ENROLLED RESOLUTION 174-002

AMEND THE REGIONAL WATER QUALITY MANAGEMENT PLAN FOR
THE VILLAGE OF DOUSMAN, WAUKESHA COUNTY, WISCONSIN

SEWRPC STAFF MEMORANDUM

RESPONSE TO REQUEST BY THE VILLAGE OF DOUSMAN TO AMEND THE DOUSMAN SANITARY SEWER SERVICE AREA

Map 1

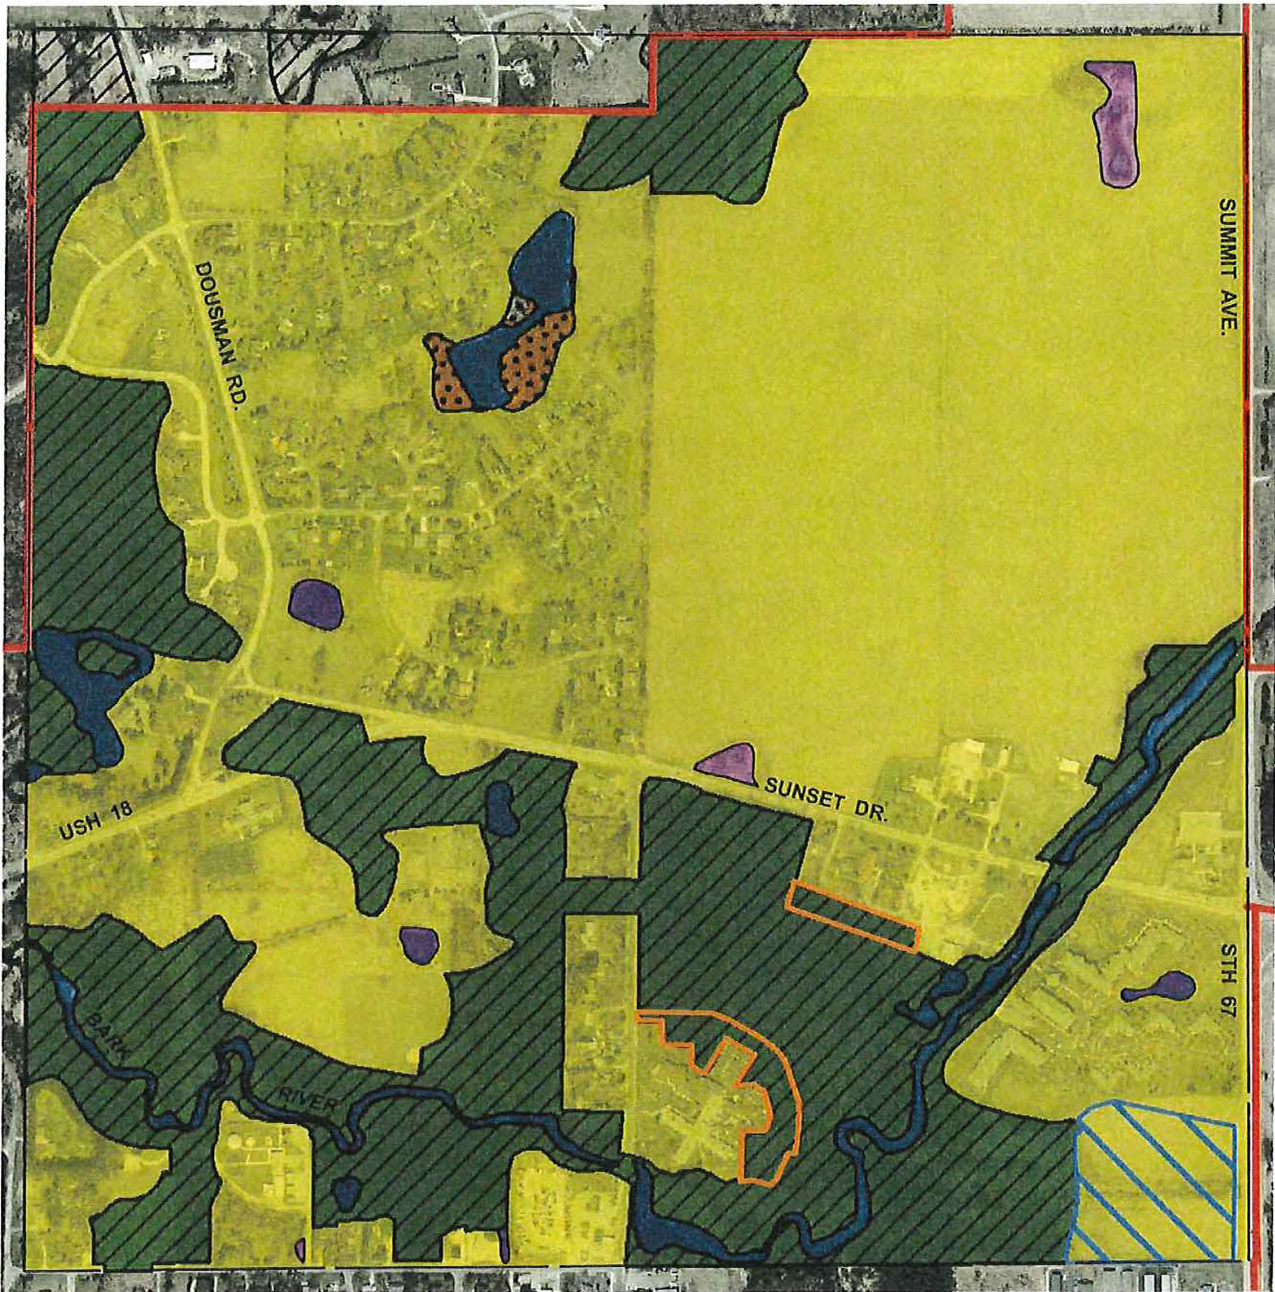
This amendment involves a proposed reshaping of the primary environmental corridor within the Grand Masonic Lodge of Wisconsin/Three Pillars Senior Living Community property located in an area bounded by Main Street, STH 18, and STH 67 in U.S. Public Land Survey Section 34, Township 7 North, Range 17 East, in the Village of Dousman. The amendment is intended to accommodate expansion of the Grand Masonic Lodge of Wisconsin/Three Pillars Senior Living Community campus. The proposed change to the environmental corridor is shown on Map 1. Under the proposed amendment, about 5.3 acres of existing primary environmental corridor would be disturbed to accommodate the expansion of the campus. This would be mitigated through the expansion of the existing environmental corridor by about 10.2 acres on the southeastern part of the property as shown on Map 1. A detailed mitigation plan identifying the types and amount of native vegetation to be planted and details for vegetation monitoring and maintenance has been approved by the Village. By adopting this sewer service area amendment, the Village of Dousman commits to ensuring that the mitigation plan is implemented.

The proposed modification of the primary environmental corridor on the subject property does not change the outer boundary of the planned sewer service area.

PROPOSED CHANGES TO PRIMARY ENVIRONMENTAL CORRIDOR
IN THE VILLAGE OF DOUSMAN SANITARY SEWER SERVICE AREA

NOTE: This map replaces a portion of Map 9-2, page 28, of SEWRPC Community Assistance Planning Report No 192 (3rd Edition), Sanitary Sewer Service Area for the Village of Dousman and Environs, Waukesha County, Wisconsin, March 2007.

Given all of the foregoing, it is recommended that the Southeastern Wisconsin Regional Planning Commission formally amend the Village of Dousman sanitary sewer service area as documented in SEWRPC Community Assistance Planning Report No. 192 (3rd Edition), in the manner shown on Map 1. It is also recommended that the Wisconsin Department of Natural Resources approve this sewer service area plan amendment and transmit the plan amendment to the U.S. Environmental Protection Agency for certification.
